PLANNING TECHNICAL REVIEW COMMITTEE –AGENDA

1. 10:30 AM - 11:15 AM: Site Review for M&E Jespersen Realty, Assessor's Map K, Lots 31 & 40B, zoned B-3, located at 5 & 11 Dover Point Road. (Parking lot resurfacing project to affect 74,100 sq. ft., located at Dover Chevrolet). [*Previously heard on August 6, 2015*]. (P15-42)

Re: Response to Comments
Technical Review Committee
M&E Jespersen Realty (Dover Chevrolet)
Dover, New Hampshire

Date: October 7, 2015
To: Steve Bird, Dover Planning Department
From: Jason Hill
Re: 45488.23
Subject: Dover Chevrolet storm runoff

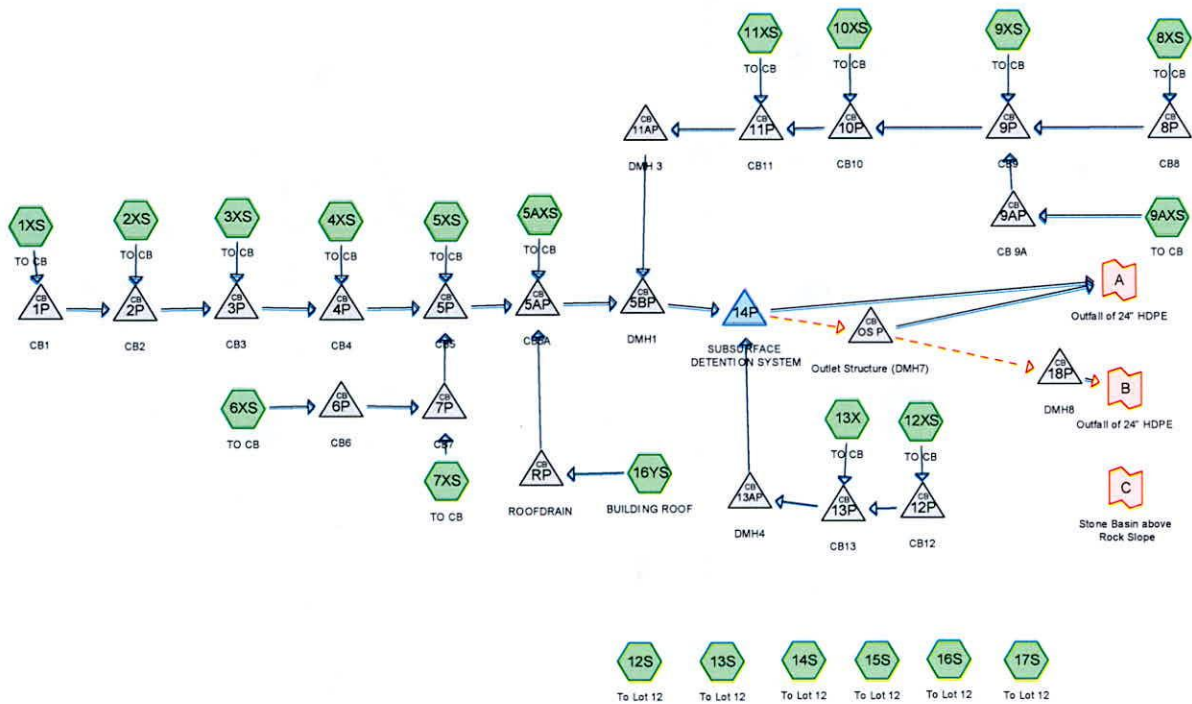
At the Technical Review Committee Meeting on August 8, 2015, there was a question of whether the new underground storm system at Dover Honda had been designed to handle runoff from the adjacent Dover Chevrolet. Storm runoff from the Honda site is collected by catch basins and flowed to a new underground system located on the west side of the property. Due to existing topography, the northerly portion of the Chevrolet parking lot also drains onto the Honda site, and is captured by its proposed stormwater management system (refer to attached Post Development Drainage Plan). This Chevy runoff was modeled into the design of the new system for the Honda development (refer to the attached HydroCAD routing diagram from the approved Honda Site Plan).

The remaining runoff from the Chevrolet property either sheet-flows westerly onto the stone lined slope (from the west parking lot), is captured by catch basin and discharged at the west slope (from the southwest parking lot), or is captured by catch basin and discharged to the city's system in Dover Point Road (from the east parking lot and roofdrain). Refer to the attached Post Development Drainage Plan.

SHEET 1

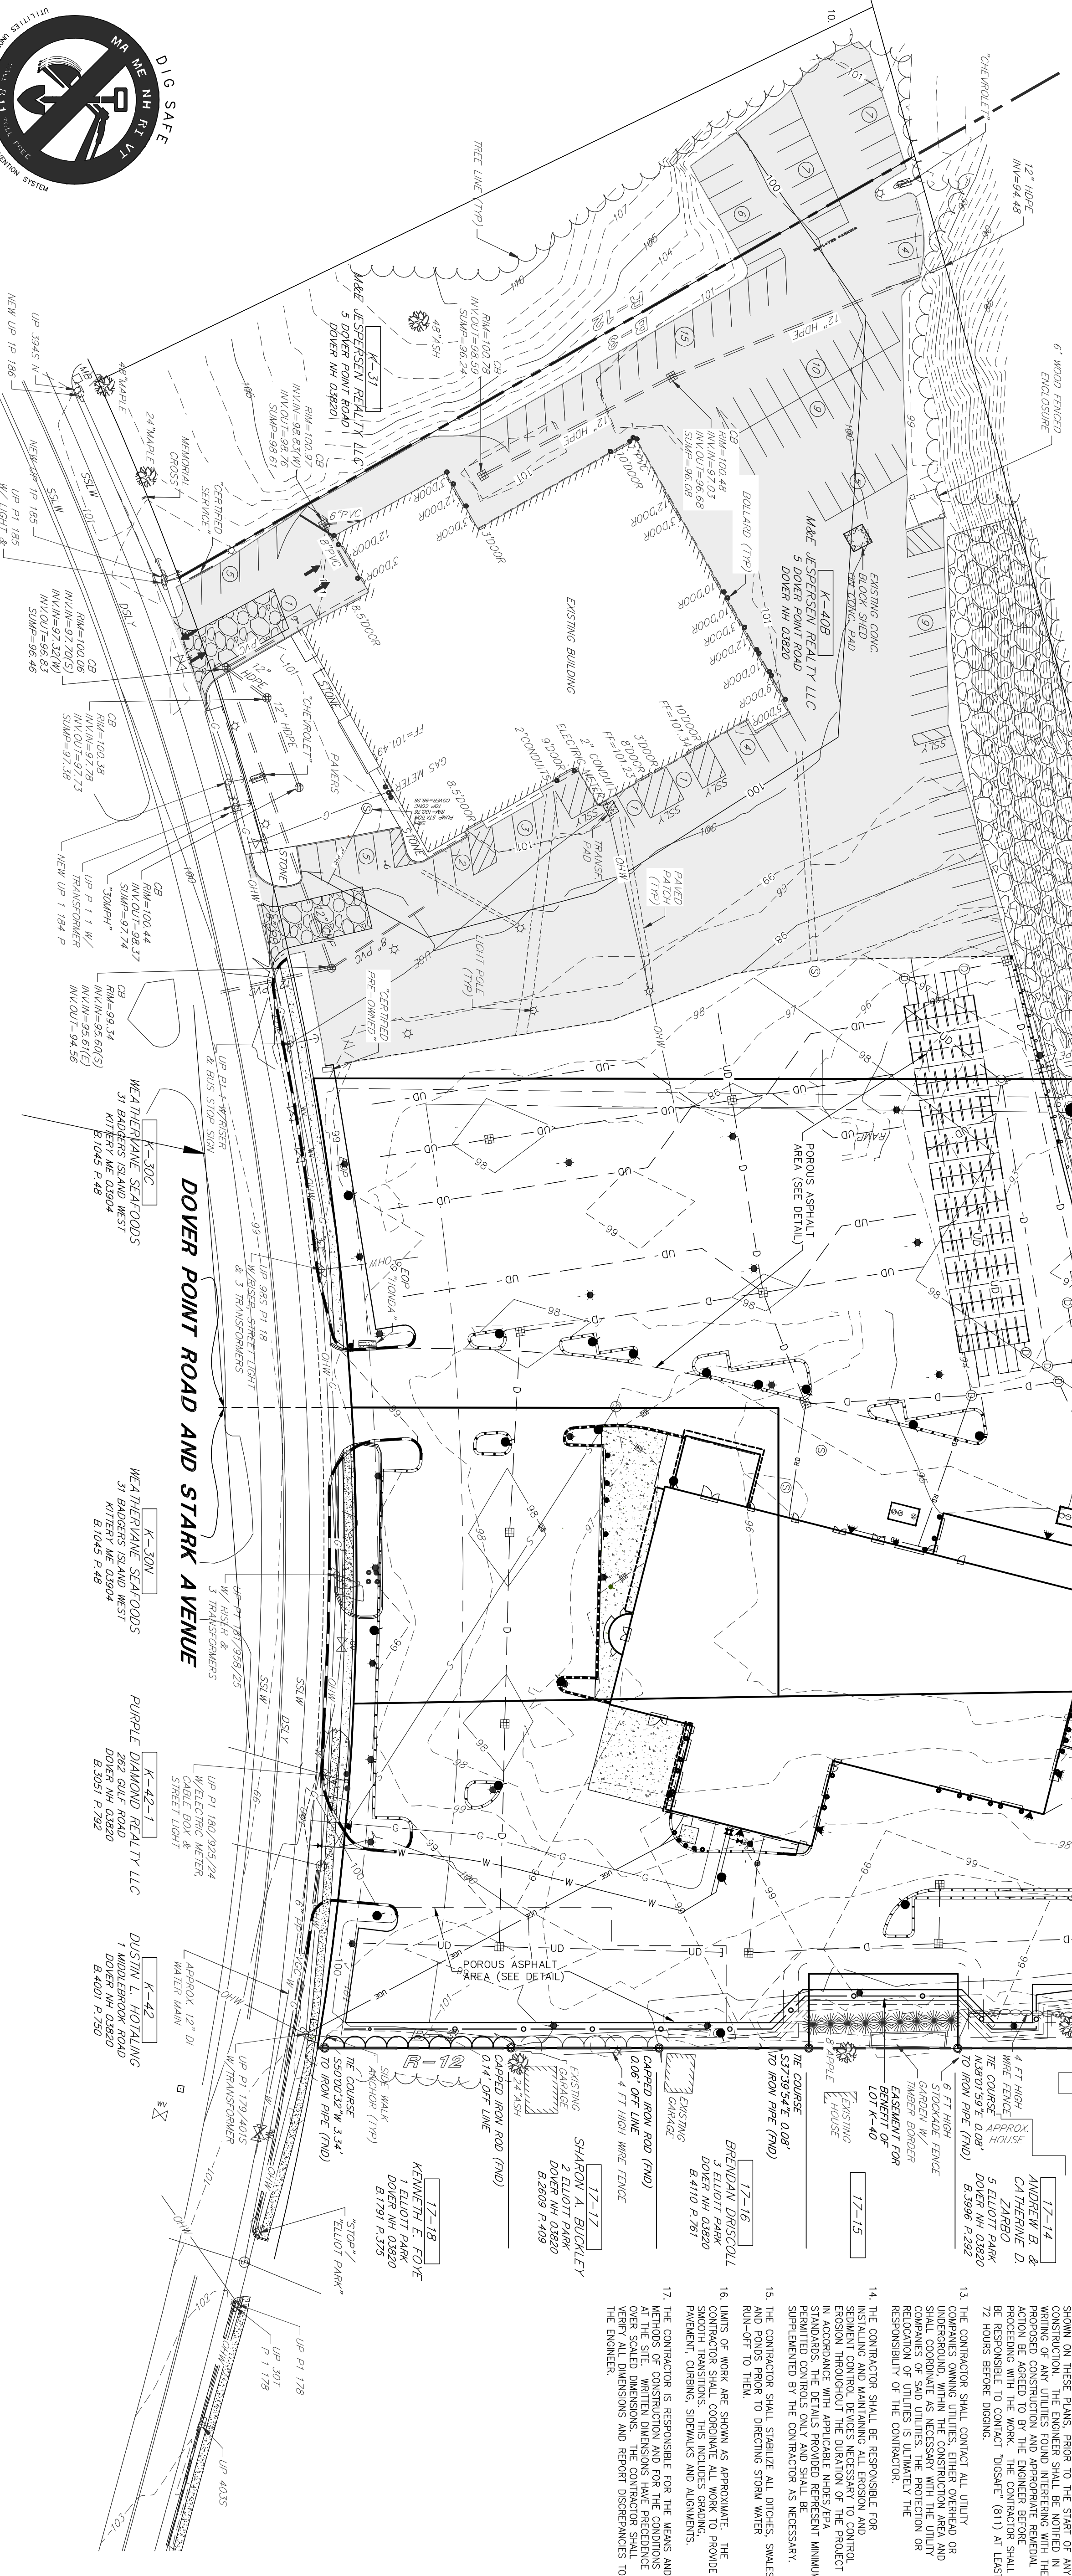
- We have added the design information for the adjacent Honda Dealership to the plans to depict the anticipated existing conditions.
- The improvements associated with the redevelopment of the adjoining Honda site include installation of porous pavement which extends onto the Chevrolet property. As such, the applicant is reducing the impervious footprint on both Honda (Lot K-40, K-40A, K-40C) and Chevrolet (Lots K-31 and K-40B) sites. The pavement area is being reduced by 9220 square feet from 1.97 acres to 1.76 acres due to the conversion to porous pavement. However, because the reduction leaves greater than 1.5 acre of impervious area within the Chevrolet Site, a waiver is requested from section 149-14 (5)(g) of the Site Plan Regulations.

- We have added the design information for the storm water infiltration system at the adjacent Honda Dealership to the plans to depict the anticipated existing conditions

- A waiver is requested from section 149-14 (5)(g) of the Site Plan Regulations for the porous pavement requirement. For these reasons, it is not necessary to note on the plans requirements to follow the same restrictions for winter sand and follow the OM from Honda for the porous pavement

- The new stormwater management system at Dover Honda, as demonstrated by its approved Stormwater Management Report, will significantly enhance site runoff water quality and reduce the peak runoff rates. This system has been designed to capture run-on from the adjoining Chevrolet dealership property. For these reasons, the Honda redevelopment project has accounted for water quality improvements to runoff from Dover Chevrolet.

Additionally, the presence of shallow ledge, (as shallow as 12-inches) has been identified over numerous portions of the Honda site, and are anticipated on the Chevrolet site. Installation of deeper sump catch basins will require blasting and/or rock hammering, which the applicant believes are not warranted provided the improvements described in the above paragraph. For these reasons, the applicant is proposing to preserve the existing catchbasins on the Chevrolet site.

- Enclosed please find a letter regarding the capacity of the Honda site drainage system.
- The existing underlying soils on this property are comprised of marine clays which are frost susceptible and not supportive of infiltration. For these reasons, it is not prudent or feasible to provide any infiltration prior to discharge into the state ROW

- The existing topography is such that runoff from the rear parking area flows into the Honda dealership (and not runoff over the slope), and is captured by a new catch basin which discharges into an underground filter system. For these reasons, it is not necessary to install a stone gravel filter strip along the back edge before discharging into the state ROW or install curbing and direct it to the new catch basin.

- The existing sidewalk system has been extended during the Honda project, and now extends across the Honda frontage and a portion of the Chevrolet frontage, and ends at the common driveway at Dover Chevrolet and Dover Honda. There is an existing bus stop here. As such, extending the sidewalk southerly across the entire frontage of Dover Chevrolet would create a sidewalk (extension) to nowhere. It is not sound engineering practice to create sidewalks which end abruptly.

Additionally, a new front patio was installed recently at Cheverolet. The permitting process was followed for this project, and a sidewalk was not required at that time. The repaving project is not affecting this area, so it would be a penalty to the applicant to remove portions of the previously approved improvements now.

For these reasons, it is not prudent or feasible to install curbing and extend the sidewalk along Dover Point Road along the frontage of the property.
